STAFF REPORT 8/14/2019  
APPLICATION NUMBER 19-6389  
ADDRESS: 19555 SRATRFORD  
HISTORIC DISTRICT: SHERWOOD FOREST  
APPLICANT: RACHEL PONDER

PREPARED BY: J. ROSS

## PROPOSAL

Rochelle Funder (1955 Stratford Rd.) Fencing Project

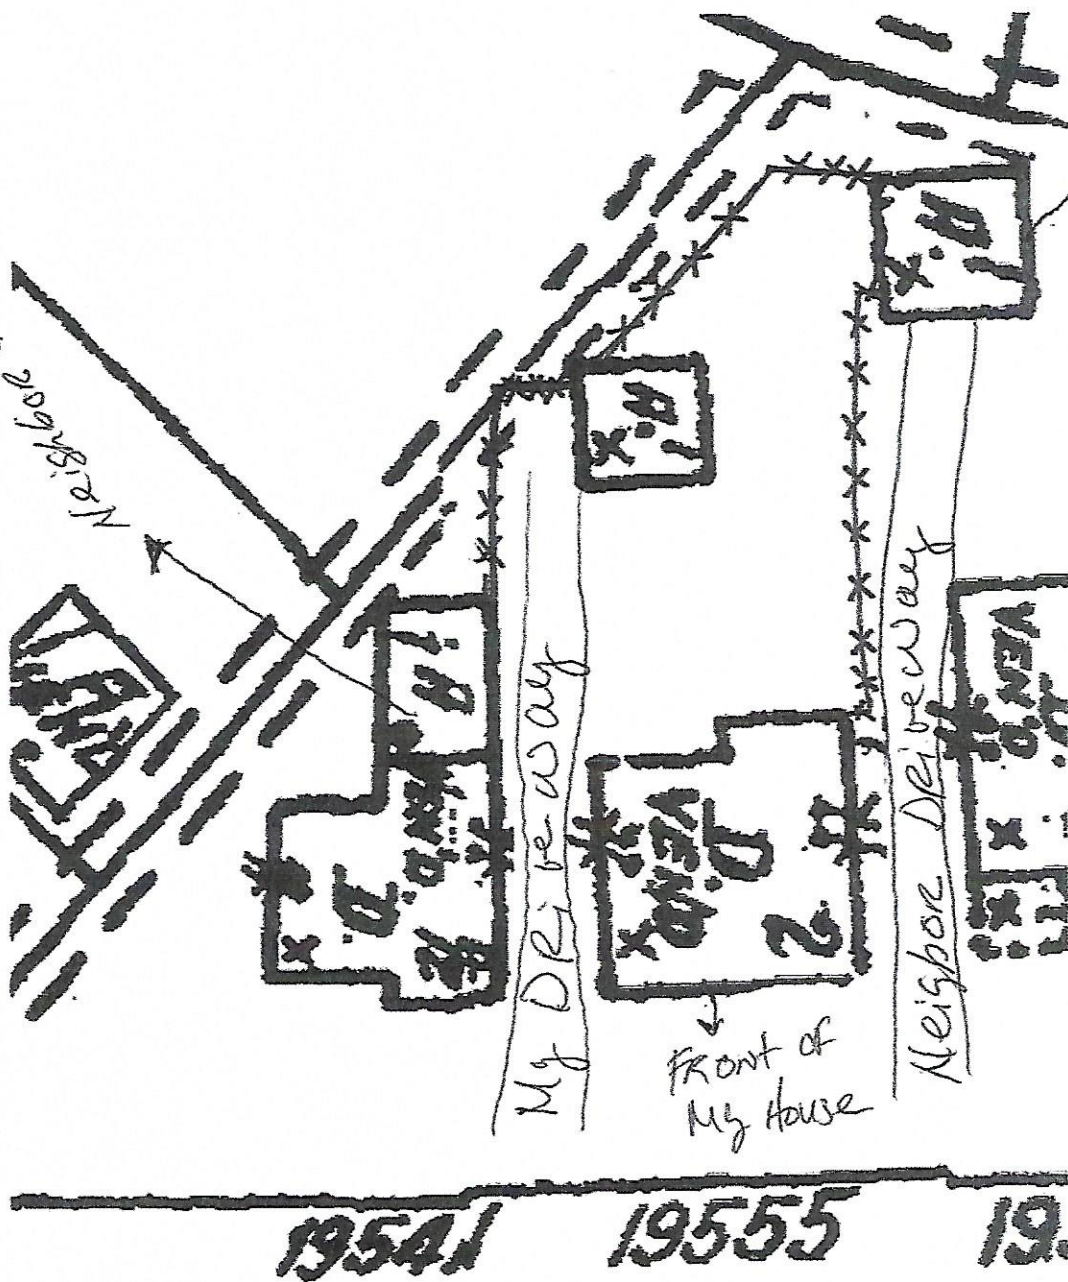
With the current proposal, the applicant is seeking to replace the existing wood rear yard fencing with new masonry walls. Specifically, please see the attached site plan, which indicates that there are currently three sections of fencing at the rear yard. Each section of fencing will be removed and replaced with a masonry wall which will measure 6'-0" in height and 8" in width. The wall's exterior surface will be finished with concrete, which will be "stamped" with a "Fieldstone" pattern on both sides. The submitted documentation indicates that the wall will be finished with a tannish-brown color, although a true representation/swatch of the finish color has not been provided. Metal solar light fixtures will top the wall as per the rendering.

As per the attached, the existing fencing which is proposed for replacement is in poor condition and is not historic-age. Also, the proposed new walls are located well to the rear of the home and will be minimally visible from the right-of-way. Finally, the Guidelines for Fences and Hedges do allow for the erection of masonry walls. Specifically, under the heading "Brick and stone," the guidelines recommend that "...the material of any masonry wall should be compatible with that of the building it abuts. However, it is staff's opinion that the wall's "Fieldstone" finish, as depicted in the submitted brochure, is not compatible with the masonry cladding at 19555 Stratford or the two homes which

It is staff's opinion that the erection of new, 6'-0"-high, 8"-wide masonry walls at the property's rear yard/as per the locations outlined in the submitted site plan will not destroy historic materials, features and spatial relationships that characterize the property. However, the proposed "Fieldstone" finish is not compatible with the home's and/or district's "...historic materials and features," in staff's opinion. Staff recommends that the Commission issue a Certificate of Appropriateness for the erection of new, 6'-0"-high, 8"-wide masonry walls at the property's rear yard/as per the locations outlined in the submitted site because the work meets the Secretary of the Interior Standards, standard # 9). *New additions, exterior alterations or related new construction will not destroy historic materials, features and spatial relationships that characterize the property. The new work will be differentiated from the old and will be compatible with the historic materials, features, size, scale and proportion, and massing to protect the integrity of the property and its environment.* However, staff recommends that the Commission issue this approval **with the following conditions:**

- The masonry wall shall be constructed of finished brick or finished with a material that is compatible in appearance with the home's exterior materials (buff cast stone or a stucco finish). HDC staff shall be afforded the opportunity to review and approve the final proposal prior to the issuance of the COA. Should staff find that the work does not meet the Standards, staff shall forward proposal to the Commission for review at a regular meeting.
